A. REPORT TO THE HEARING EXAMINER

Project Name: Cedar Ridge Church Expansion

File Number: LUA16-000128, ECF, CU-H, V-A

Project Summary: The applicant is requesting Hearing Examiner Conditional Use Permit, Environmental (SEPA) Review, and a Height Variance for a proposed addition to the Cedar Ridge Church. The proposed addition would include a 3,237 square foot basement, 6,210 square foot main floor, and 2,733 square foot balcony for a total area of 12,180 square feet. The proposal would increase the existing total seating capacity within the church to 301. The existing original 2,540 square foot church building would remain and would be converted to classroom and fellowship hall space. The project site totals 168,630 square feet (3.87 acres) and is zoned Residential-8 (R-8). The height of the proposed addition would result in a maximum height of 40'-1". The proposed project includes the addition of 20 parking spaces, resulting in a total of 60 parking spaces on site. Access to the site would remain off of SE 164th Street via one curb cut. A sensitive slope (grade between 25 and 40 percent) and two Category 3 wetlands have been identified on the project site (Wetlands A and B). W

① SITE PLAN
1" = 30'-0"

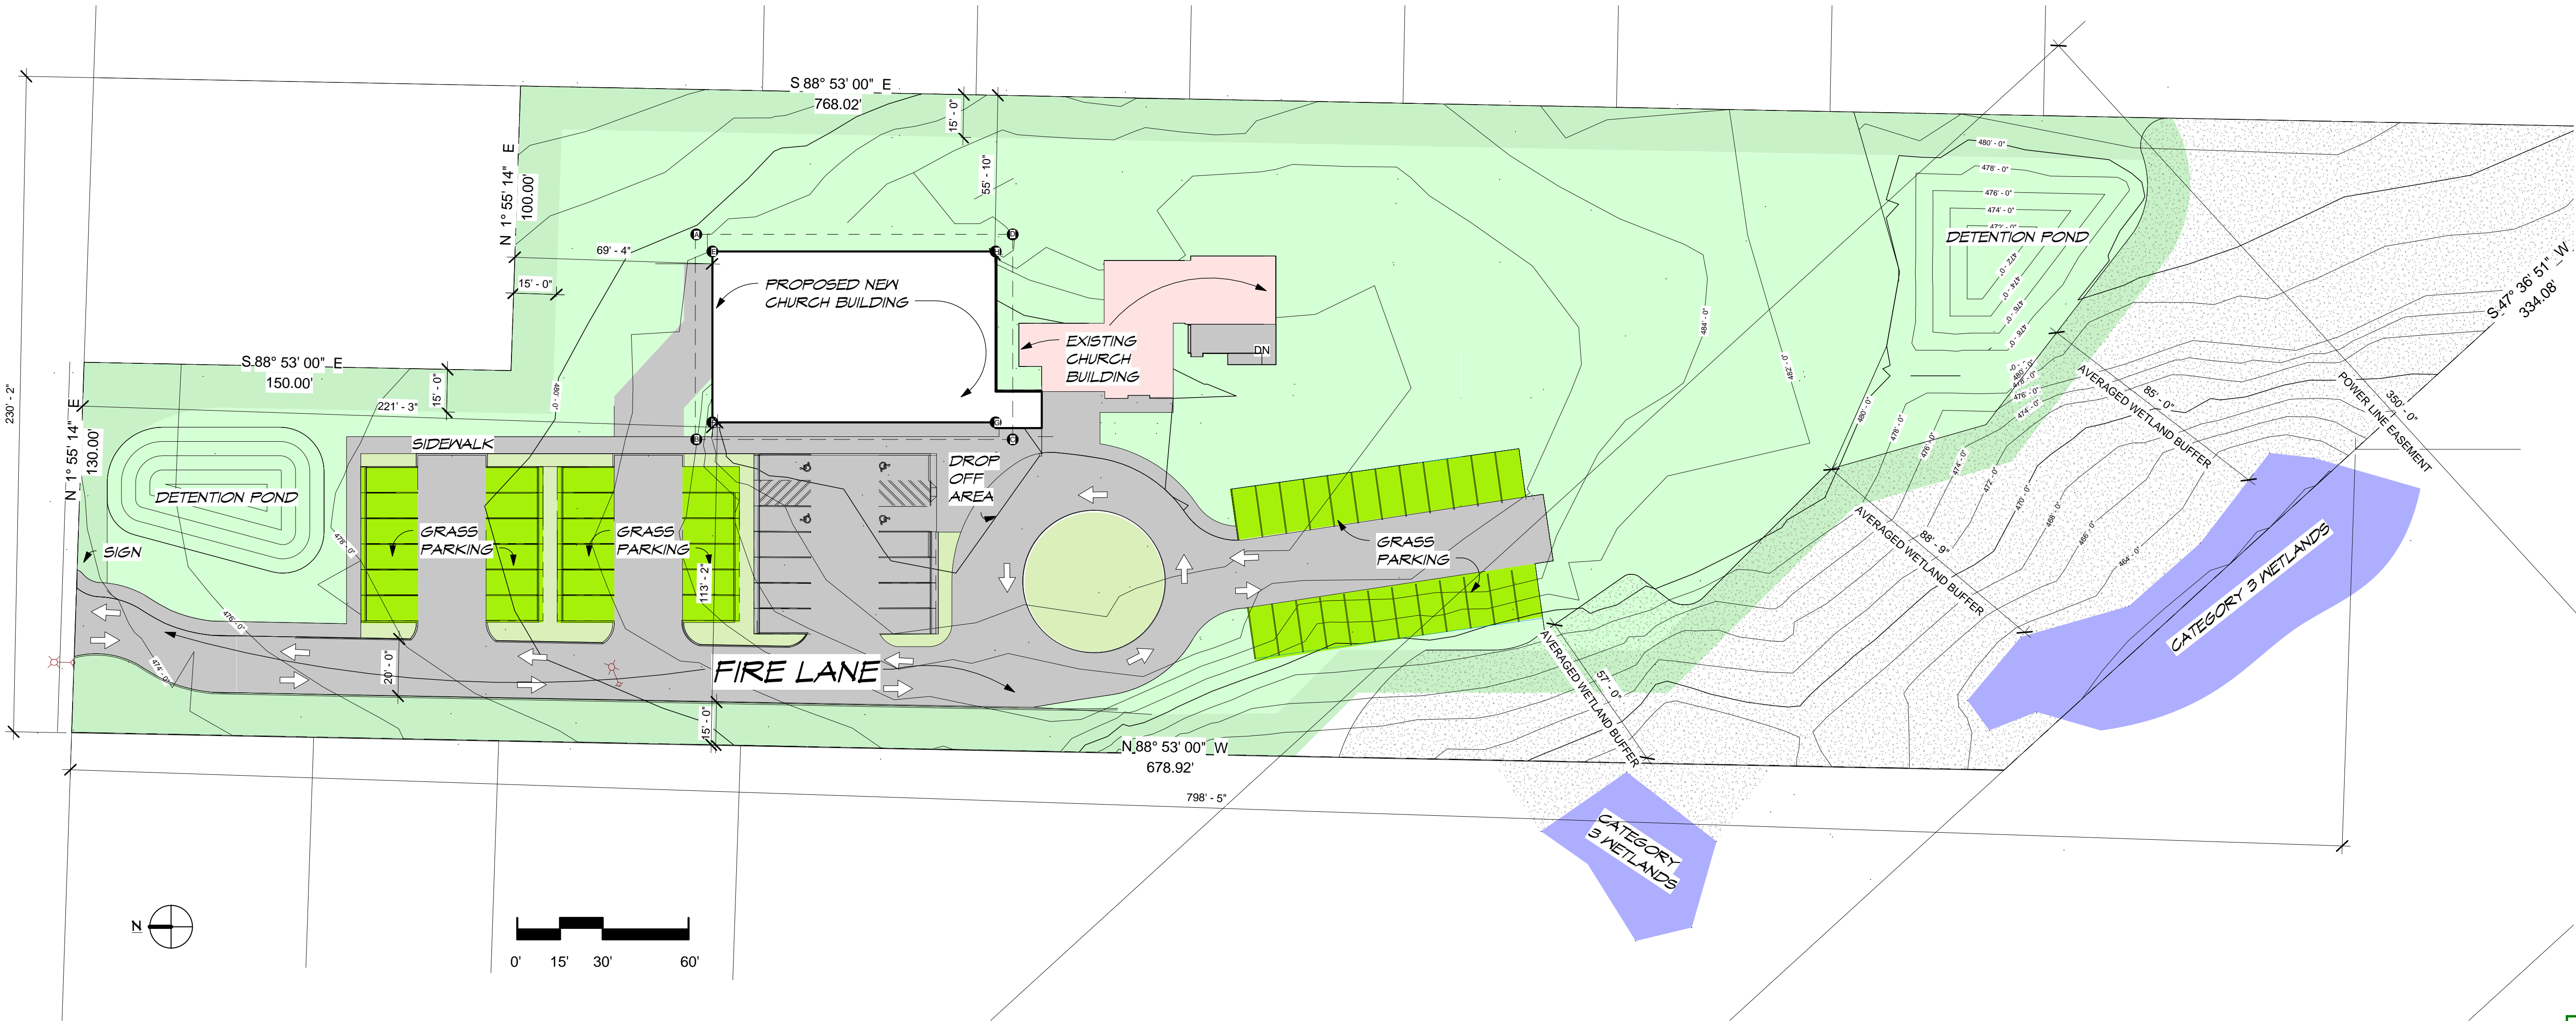
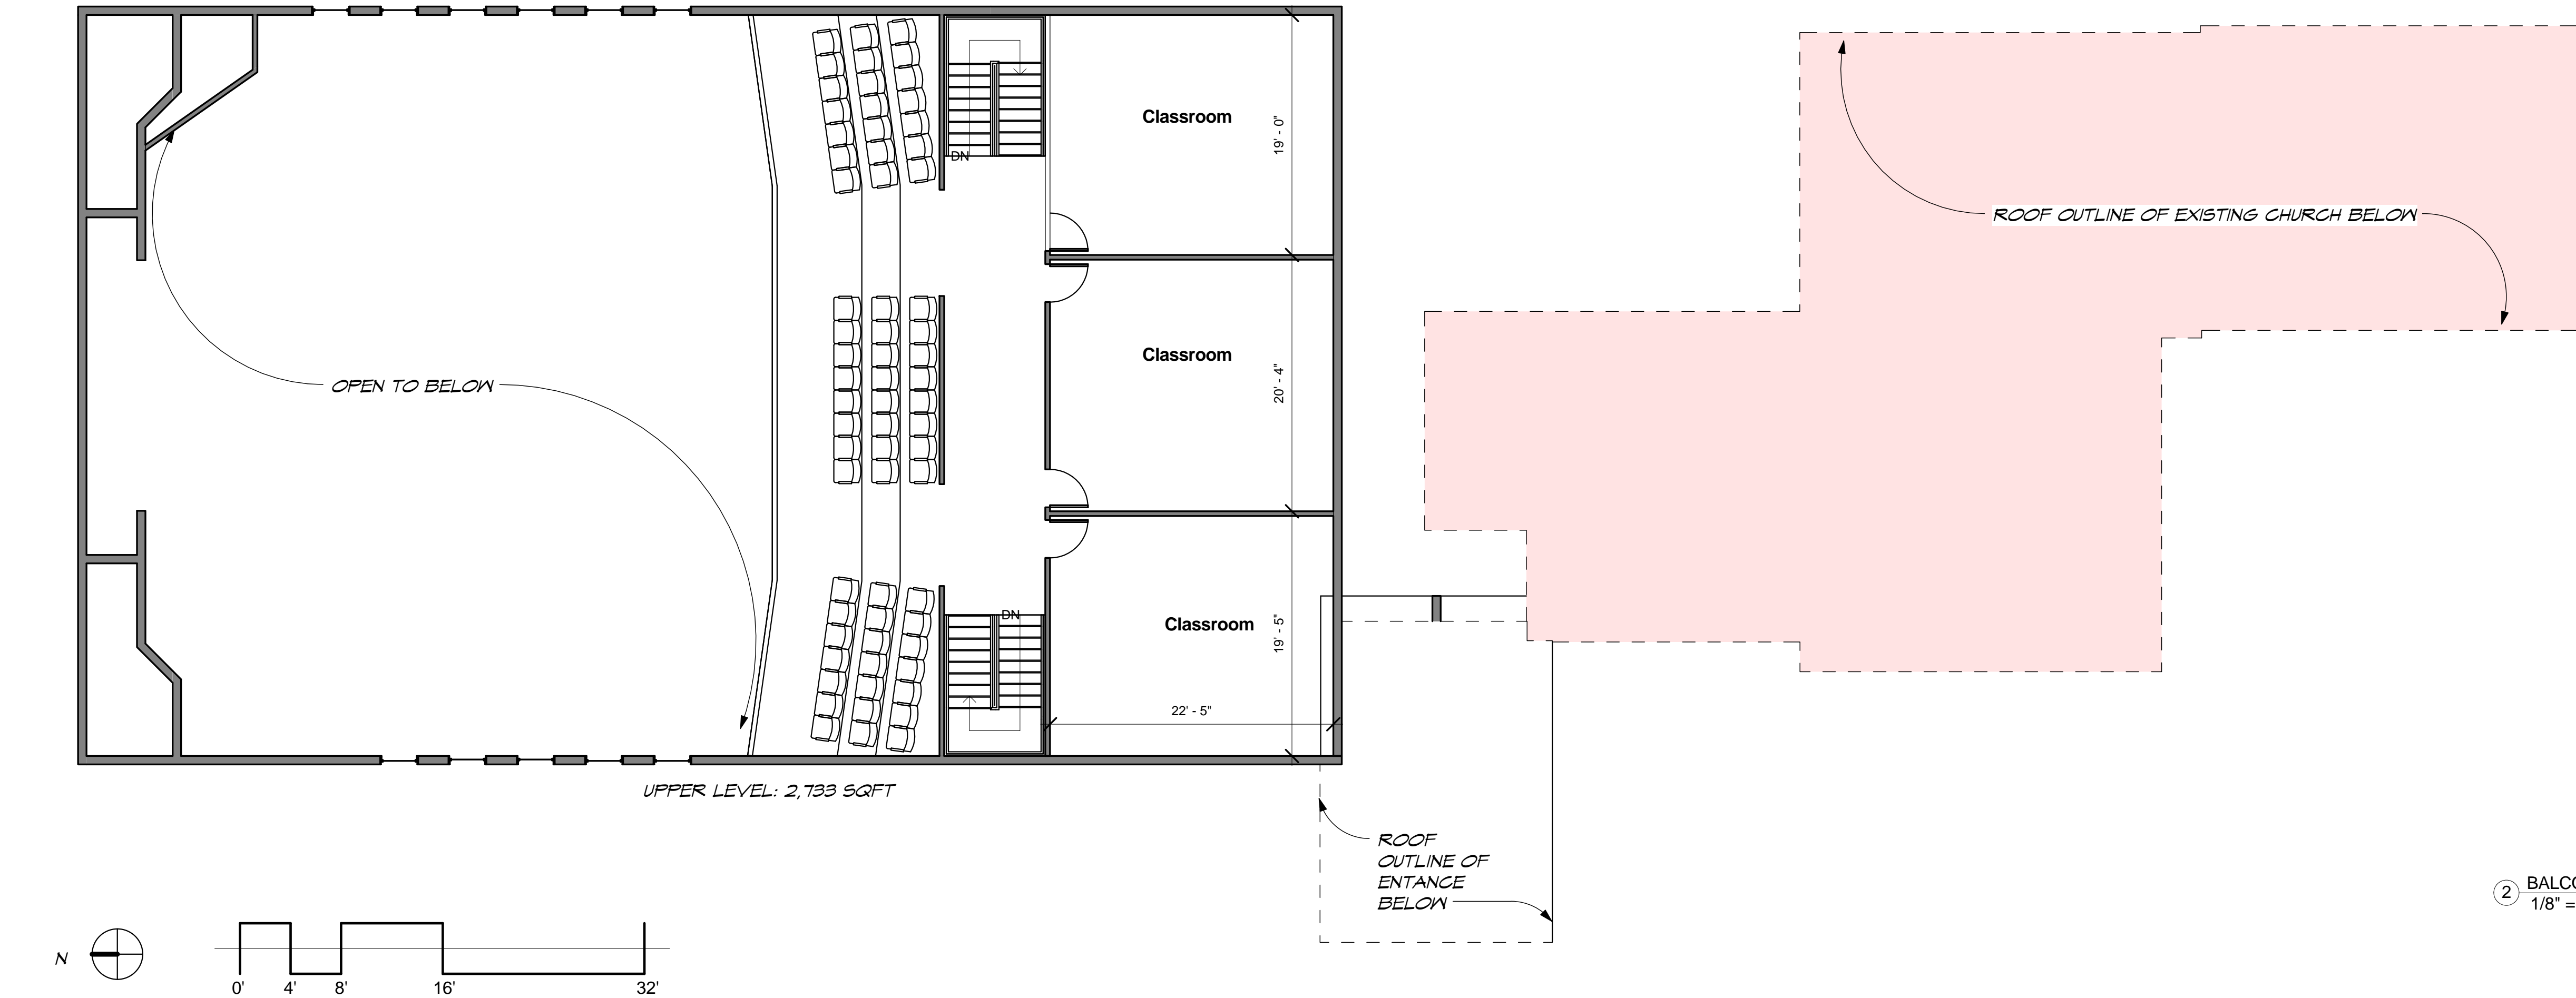
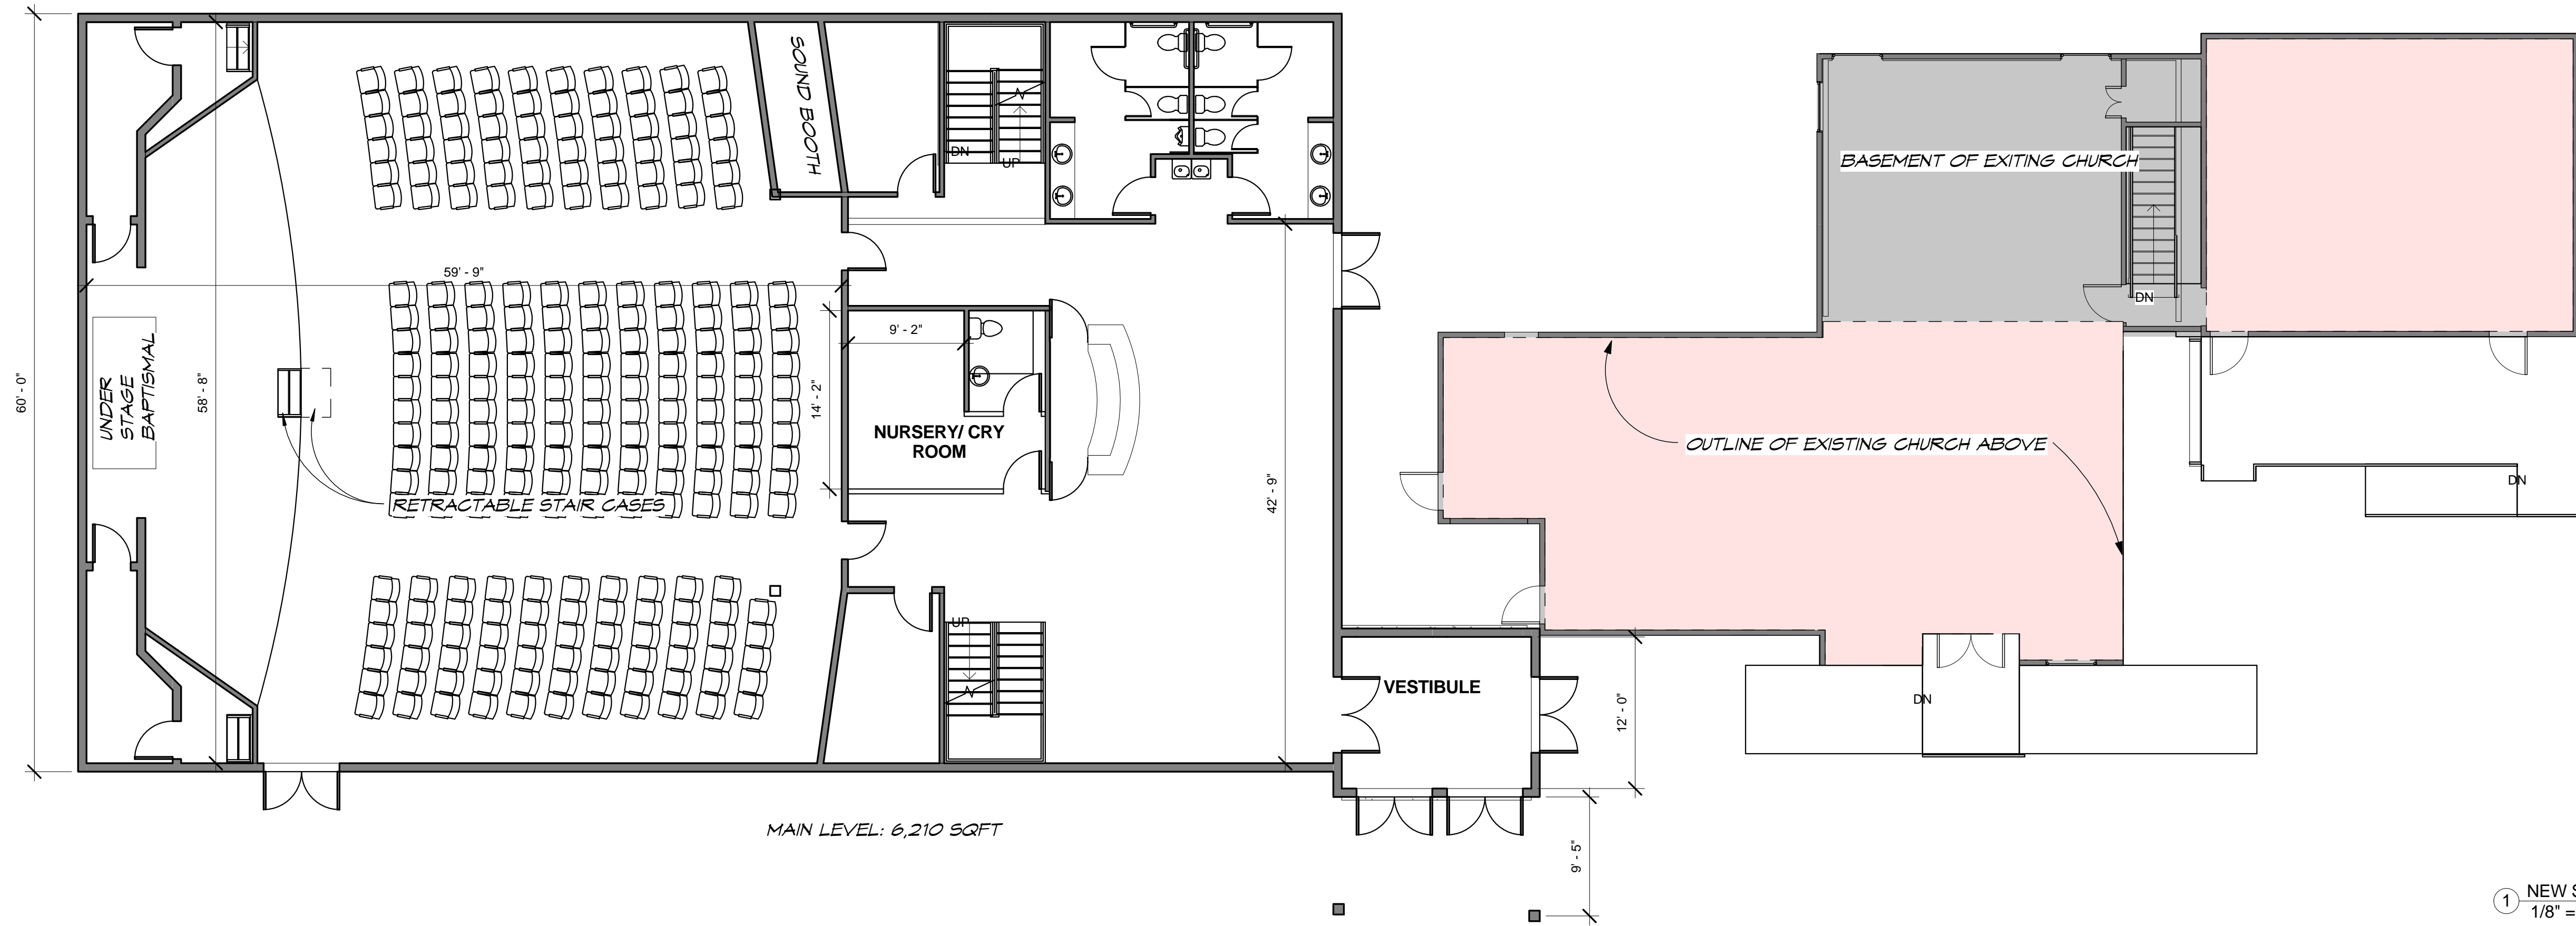
The submitted Landscape Plan (Exhibit 7), did not include the stormwater pond now proposed along SE 164th Street and subsequently did not include the 15-foot wide landscape strip around the pond. Staff recommends as a condition of approval, that the detailed landscape plan include the required 15-foot wide landscape strip around the stormwater detention ponds. The required landscape shall be located on the outside of any required fencing and shall be installed prior to Certificate of Occupancy for the proposed addition.

The new site plan proposes two detention ponds to meet the flow control requirements. The final TIR should evaluate whether the southern detention pond is still necessary due to the reduced scope of work. The site is subject to the Enhanced Basic Water Quality treatment standards. The Enhanced Basic Water Quality treatment standards may be reduced to the Basic Water Quality Treatment standards provided that an exception in Section 1.2.8.1 of the 2017 Renton Surface Water Design Manual is met. A wetpond is not a permitted Enhanced Basic Water Quality treatment device.

Locate and display the existing French drain that drains north from the project site to the Type 1 Catch Basin (COR Facility #137670) north of 11417 SE 164th Street on the drainage site plan. Show and explain how you plan to accommodate drainage from this French drain in the construction plans and final TIR.

- 5. A revised site plan shall be submitted at the time of Utility Construction Permit application demonstrating compliance with the standard wetland buffer requirements for Wetlands A and B. Wetland A was identified as having a standard buffer requirement of 100 feet. Wetland B was identified as having a standard buffer requirement of 75 feet. The revised site plan shall be submitted to the Current Planning Project Manager for review and approval prior to Utility Construction permit issuance.
